ADDENDUM NO. 3

**SPIETH HALL ROOF REPLACEMENT AND
MECHANICAL UPGRADE**

PROJECT NO. 950599

Subject: UCR Spieth Hall Roof Replacement & Mechanical Upgrades - Addendum #3

PHASING PLAN
ADDENDUM #3

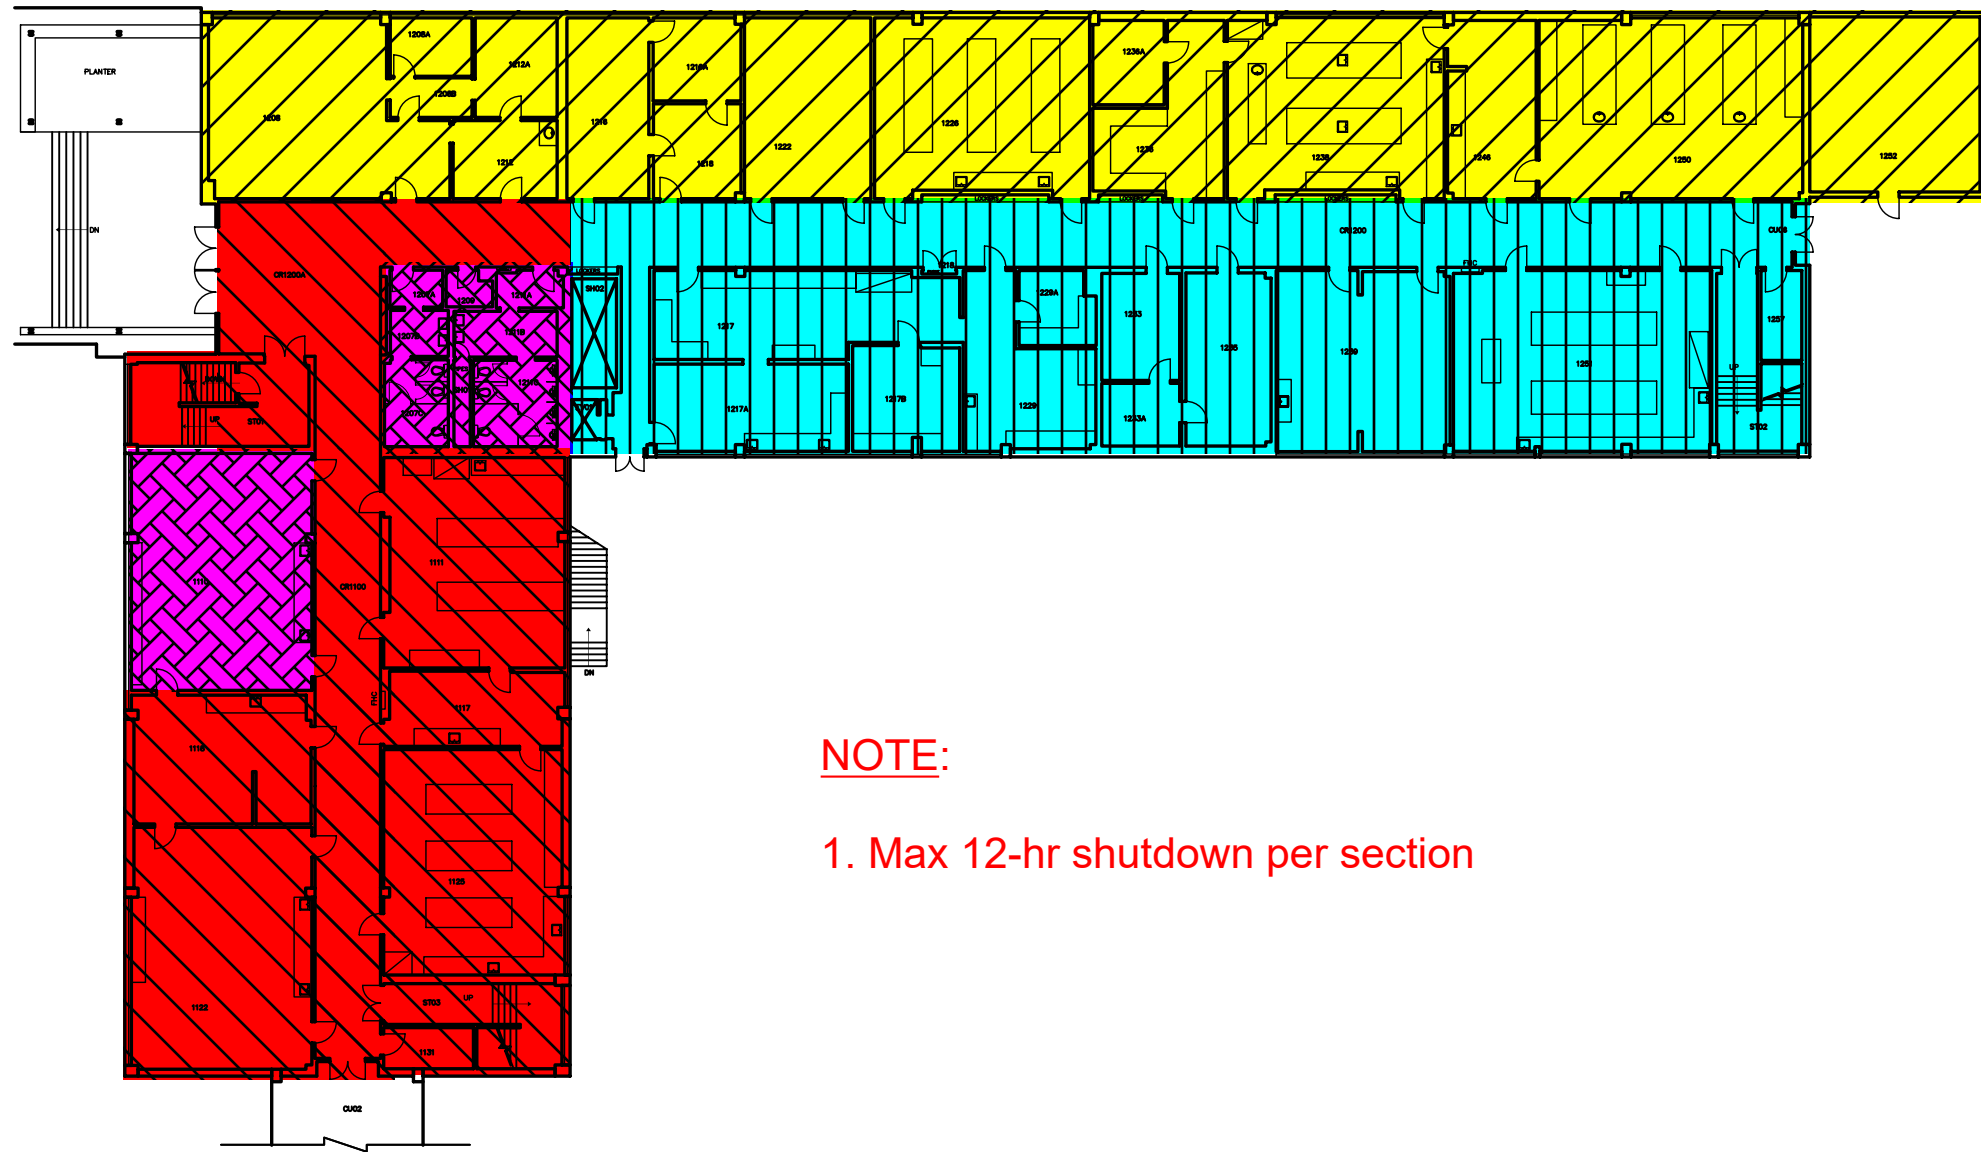
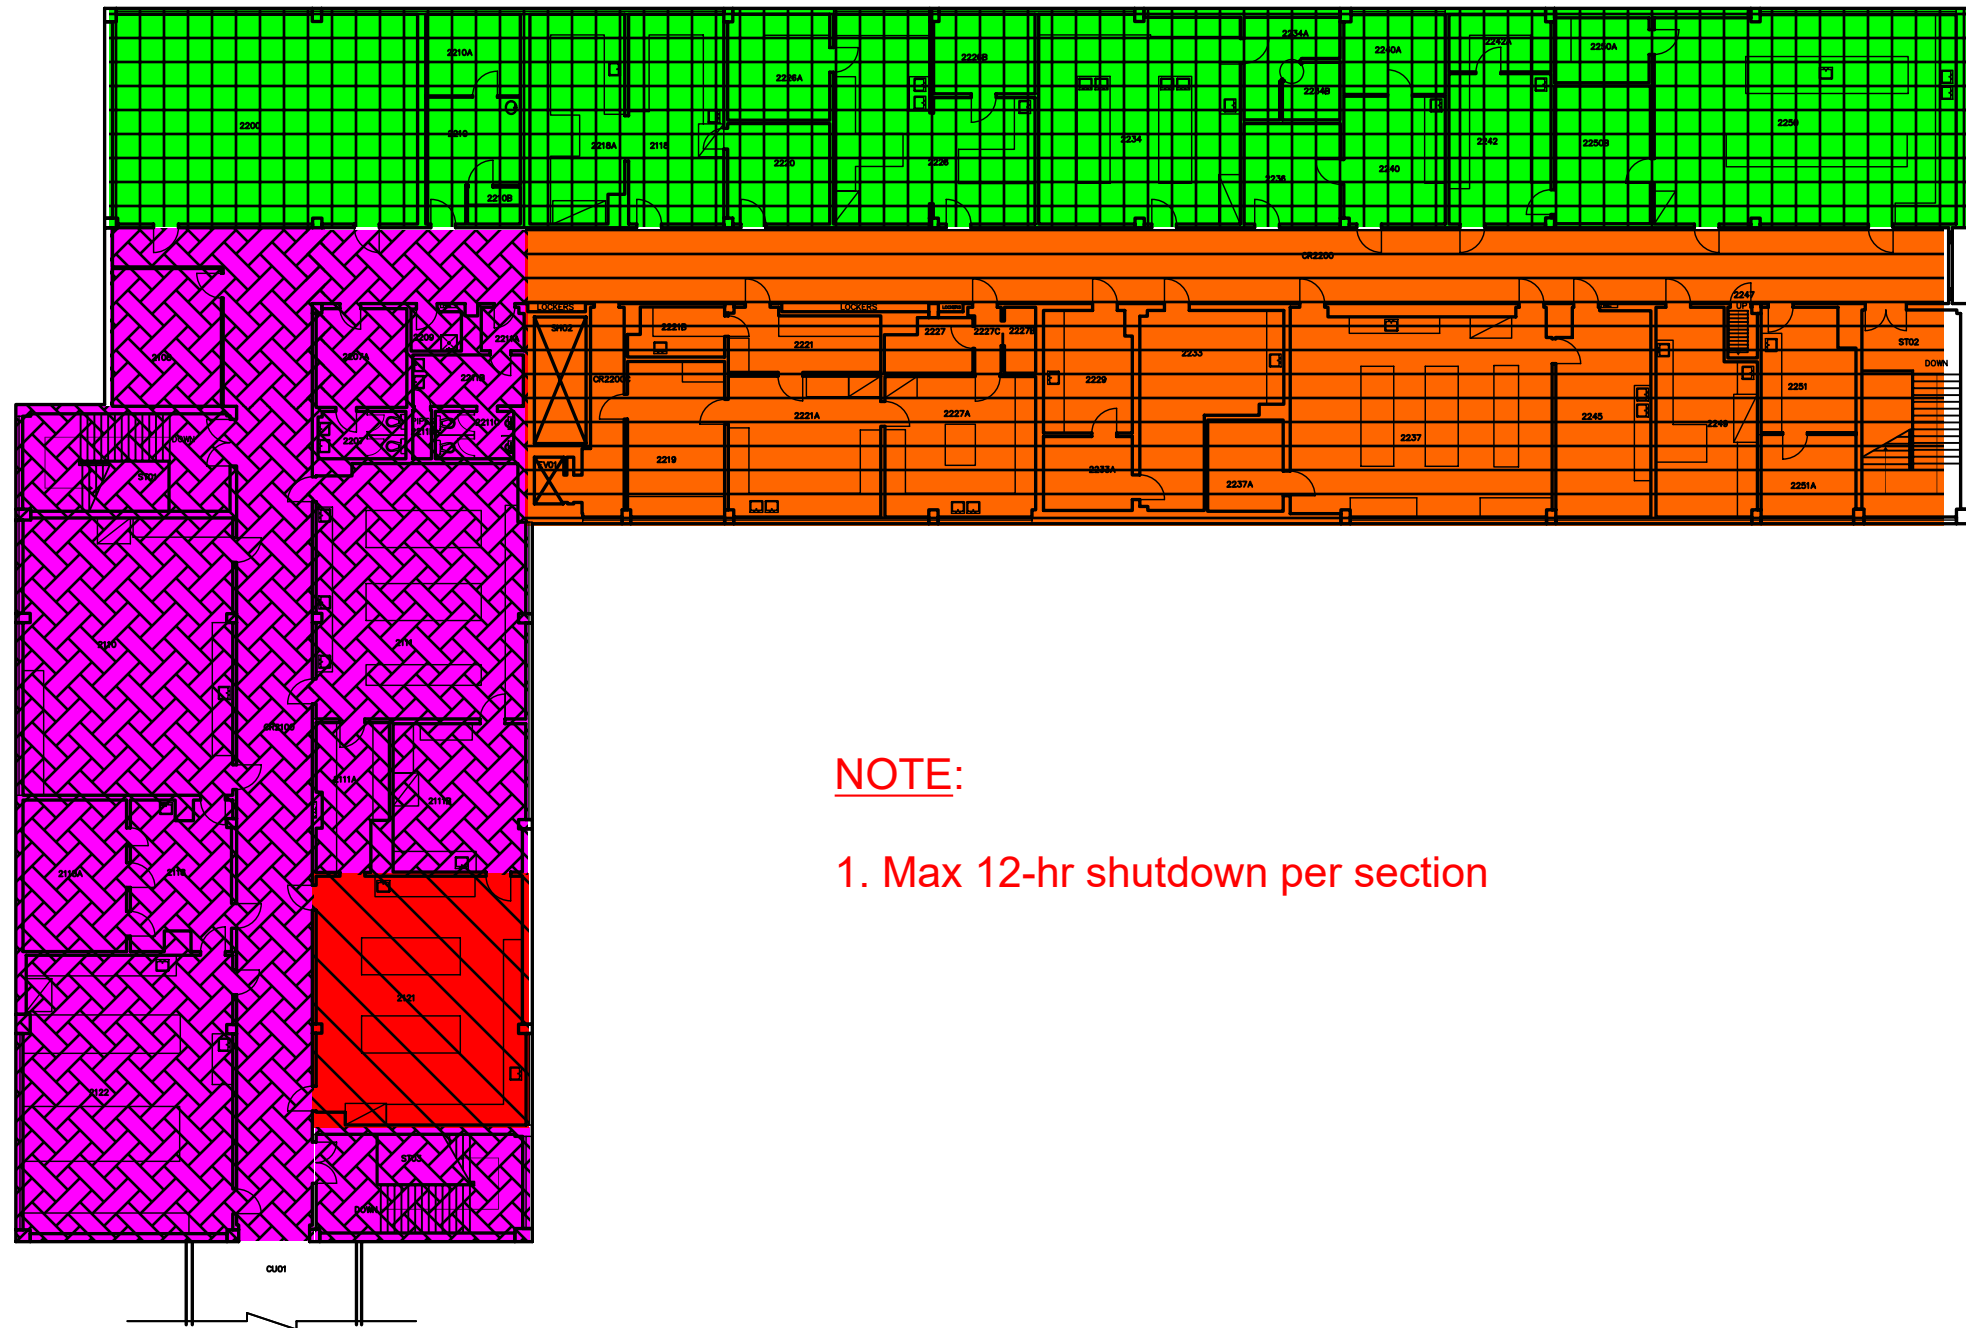
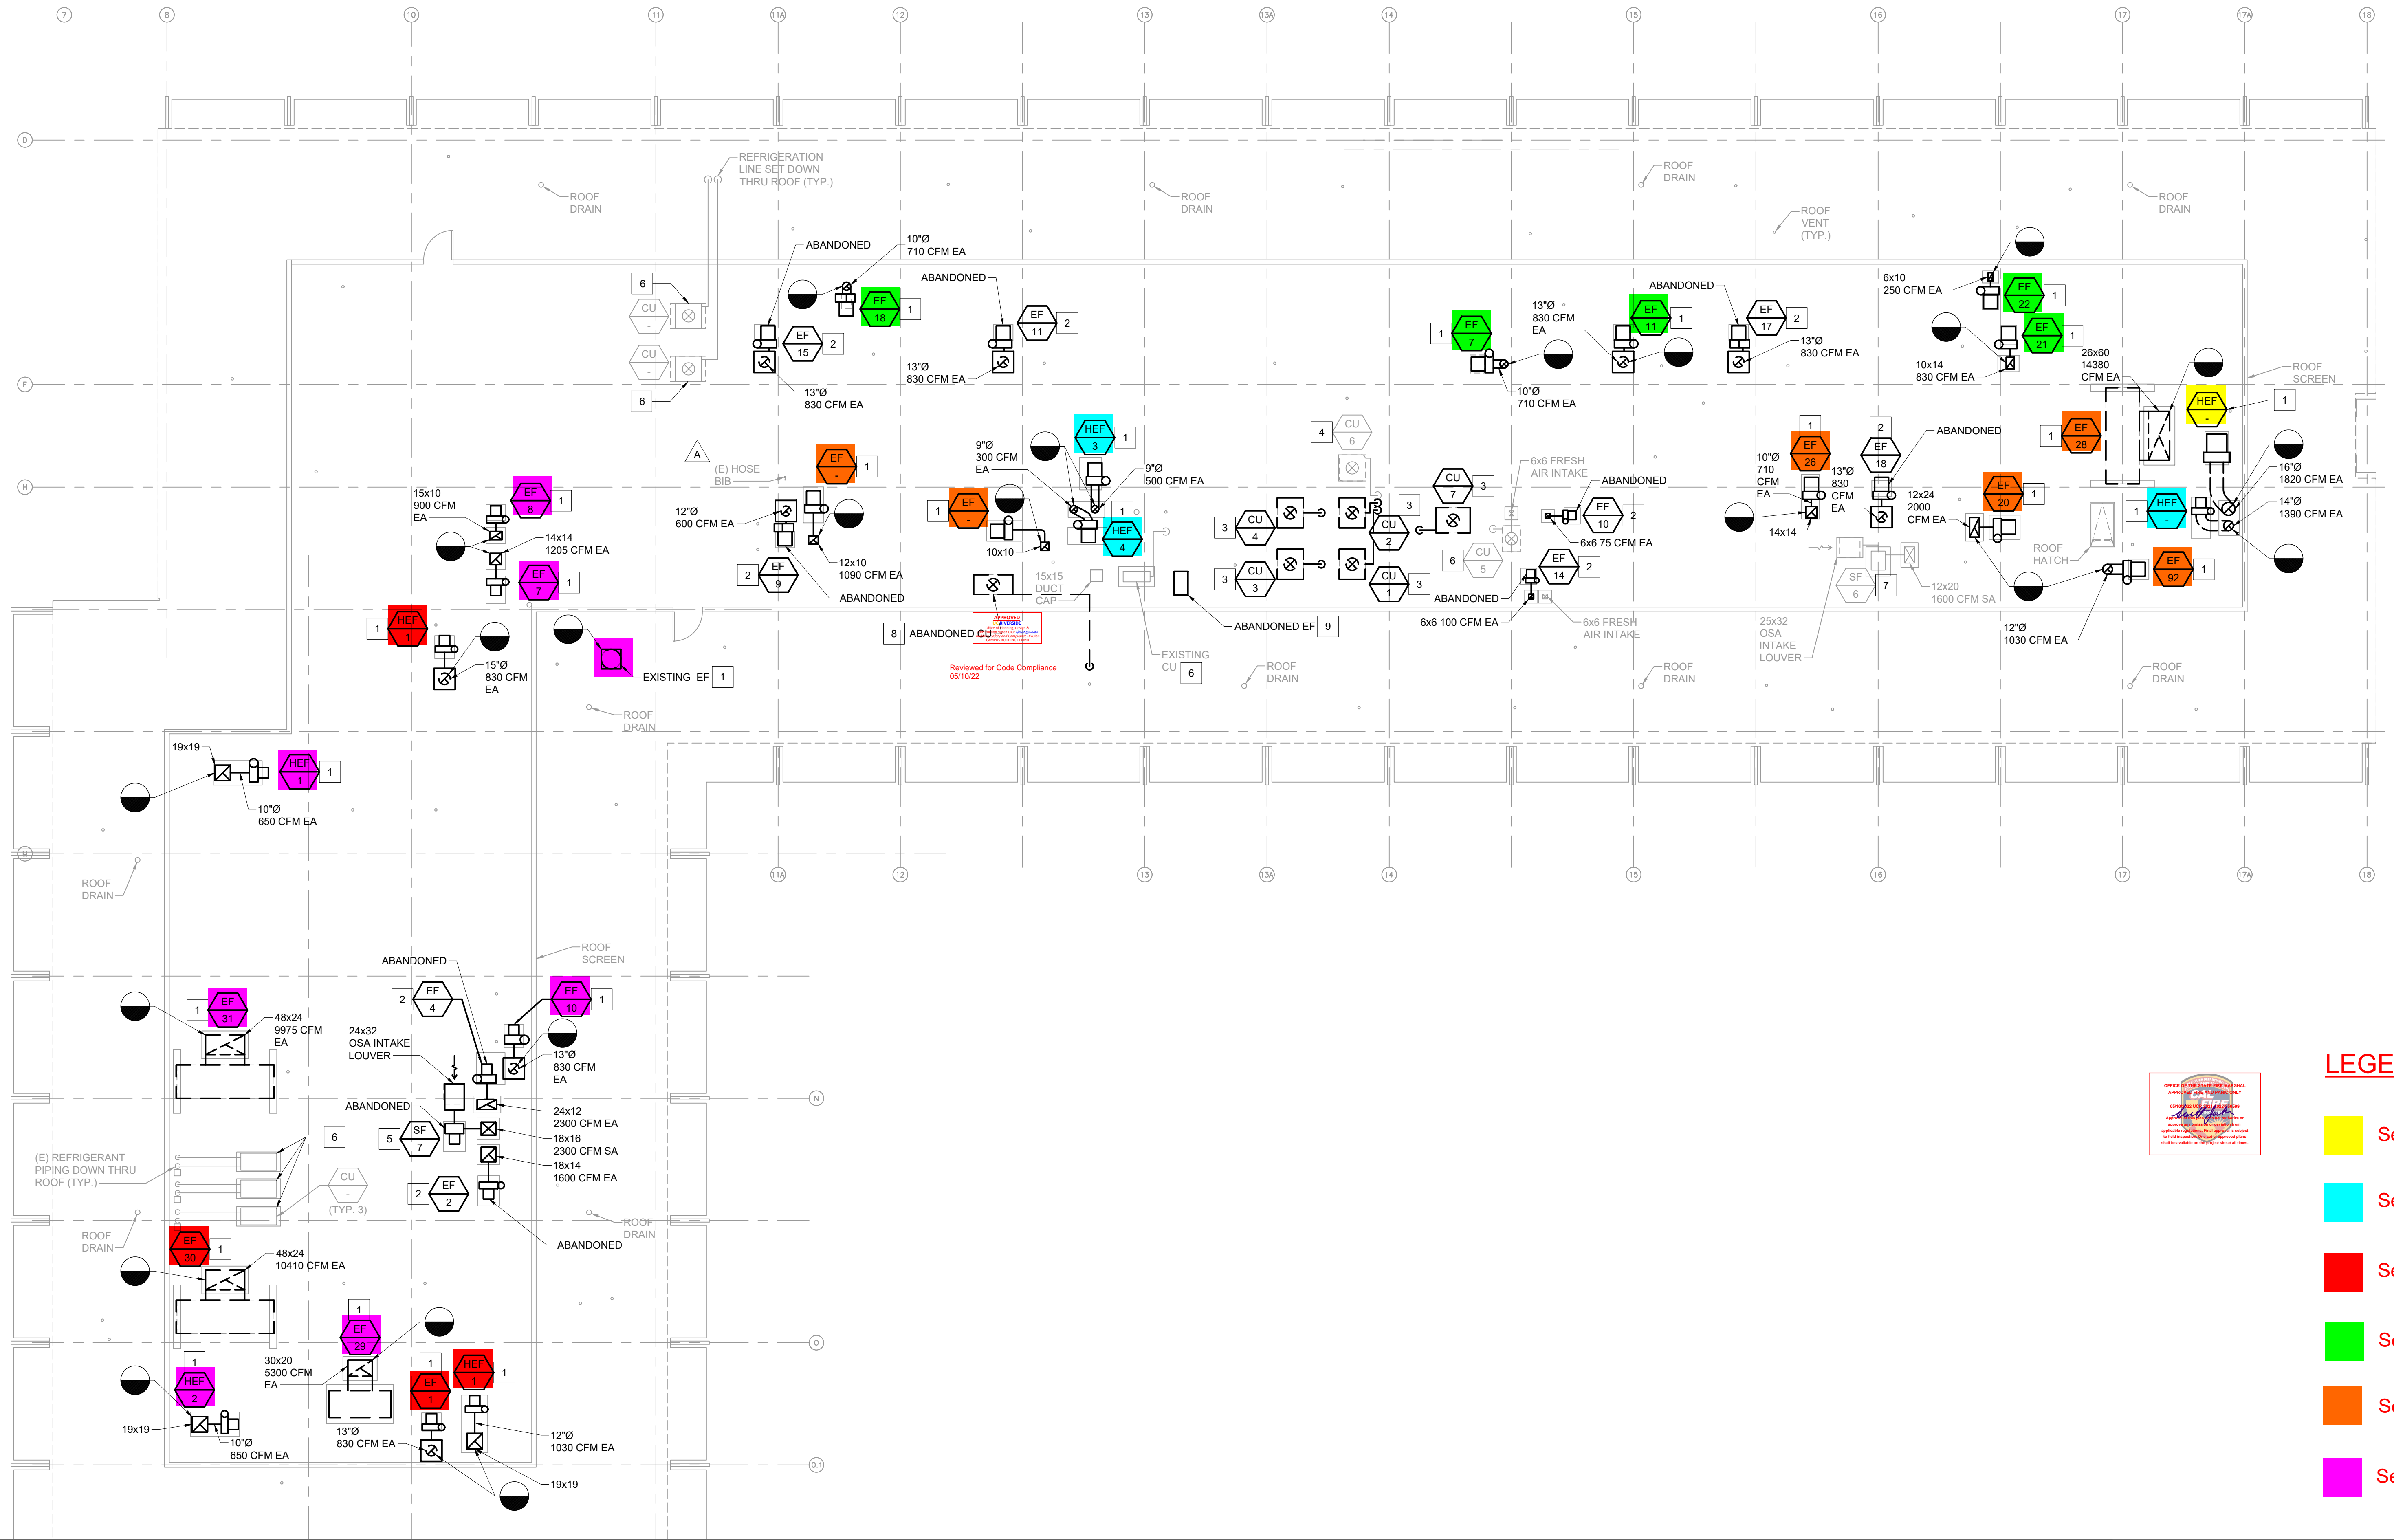
SK-1:

1. Phasing plan to allow maximum 12-hour shutdowns.

- 1. Max 12-hr shutdown per section
